Building Permit Application

Permit No.: B160007060

PROJECT:
WELLINGTON SECTION ONE, AREA 1
LOT 82
(FORMERLY KNOWN AS LOT 45)

TITLE: BUILDING PERMIT PLAN
HOUSE TYPE: STUP RESIDENCE

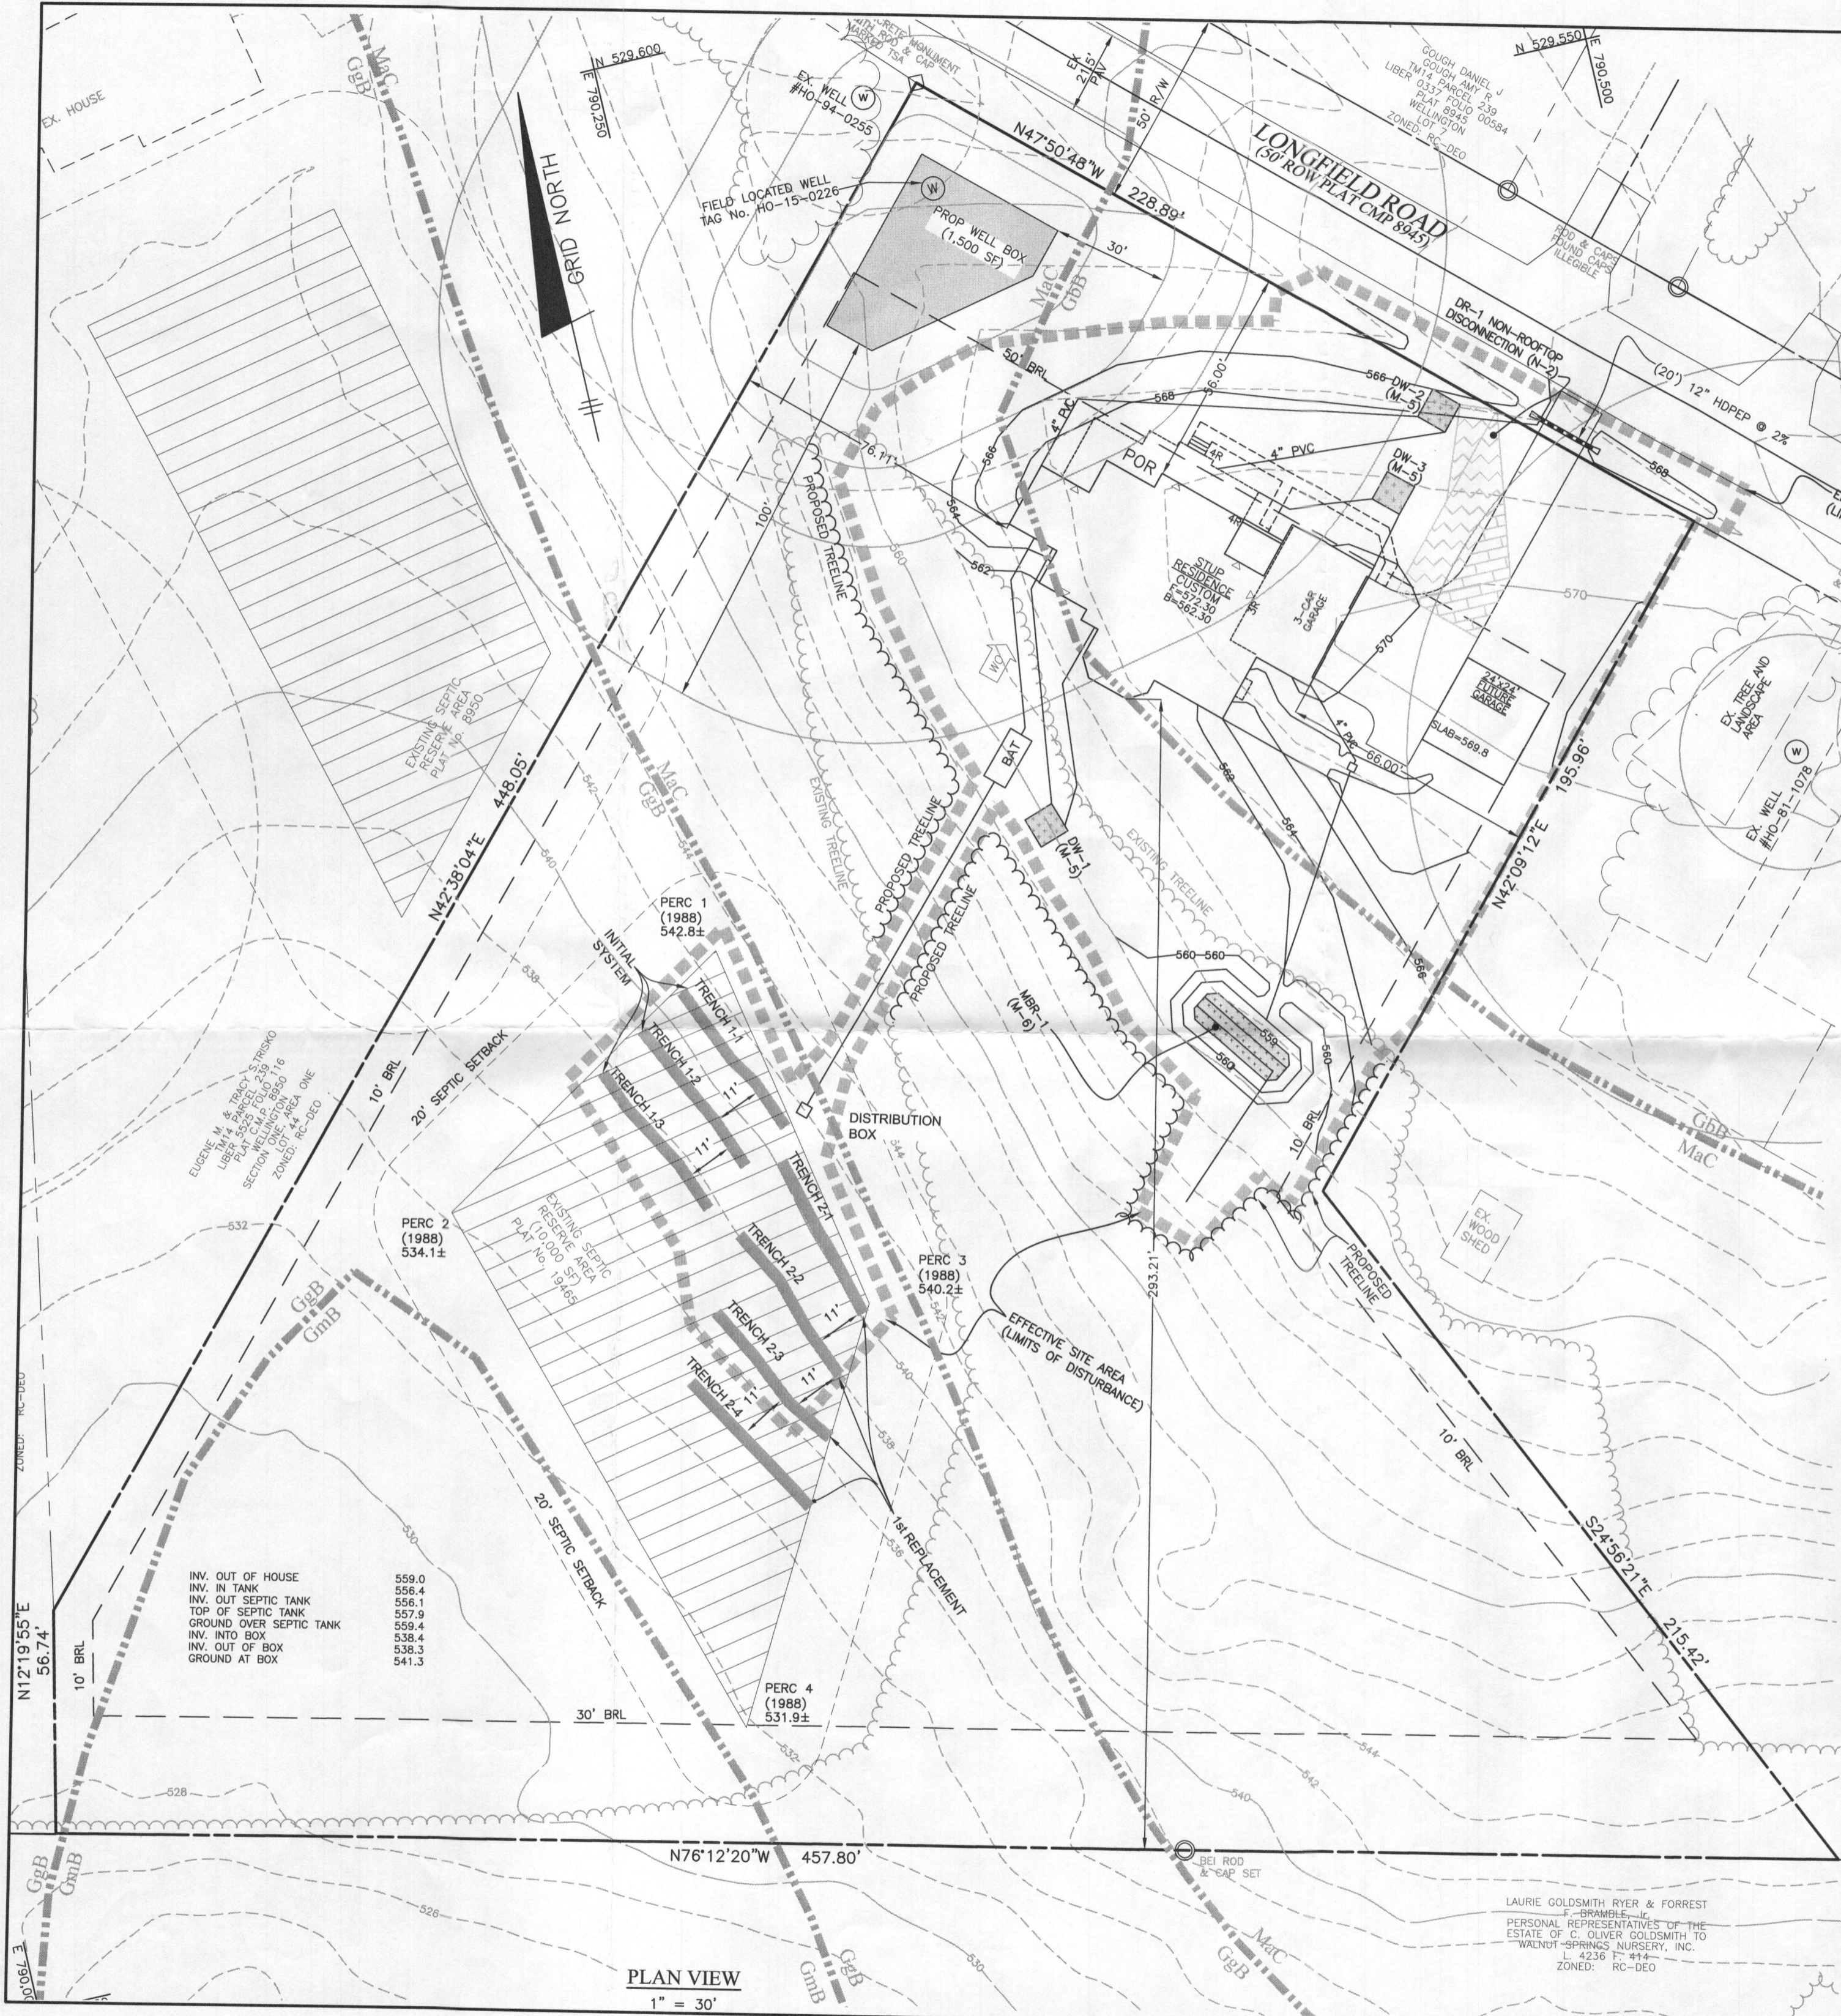
REMARKS: ① Revised general note 9 as approved by your email.

② Added general note 14 per email.

Comments concerning the plot plan include Drywell 1 (DW-1) needs to be 100^{ft} from the well box. I have attached the Spec Sheet and a link to the BAT plan checklist for your reference.

REVISED
Date: 4-28-16
Comments: revise per Health
B16000706

9. COMAR SEPTIC TANK FOR THIS LOT WOULD BE 2,000 GALLONS. THE BAT TANK SIZE IS 1,300 GALLONS.
10. THERE ARE NO EXISTING WELLS OR SEPTIC SYSTEMS WITHIN 100' OF THIS PROJECT'S BOUNDARY EXCEPT AS NOTED.

14. THE EXISTING WELL SHOWN ON THIS PLAN, HO-15-0226, HAS BEEN FIELD LOCATED BY BENCHMARK ENGINEERING, INC., AND IS ACCURATELY SHOWN.
